Having reviewed the draft text of G.8113 and G.8114, and the various comments that have been drawn to our attention the IAB Ad Hoc T-MPLS team believes that the following issues need to be addressed before these documents can be given approval for publication.

Figure 6-13 – Y.1711 defined T-MPLS OAM

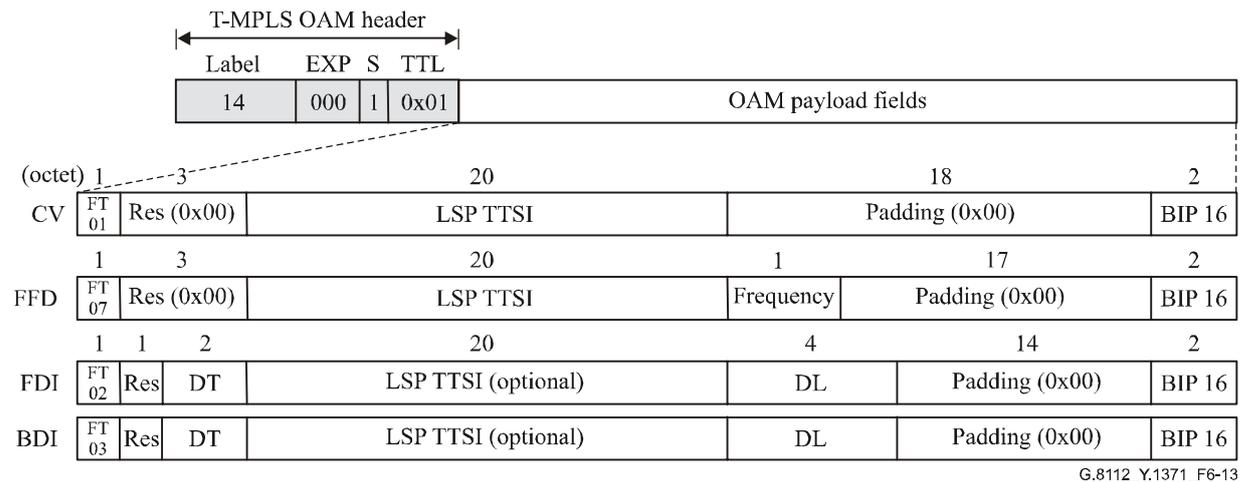
In Recommendation G.8112 section 6.2.1.1 specifies “The format of the LSP TTSI field in the FFD/CV OAM packets within the scope of T-MPLS is for further study”.

It is not clear how backward compatibility is supported.
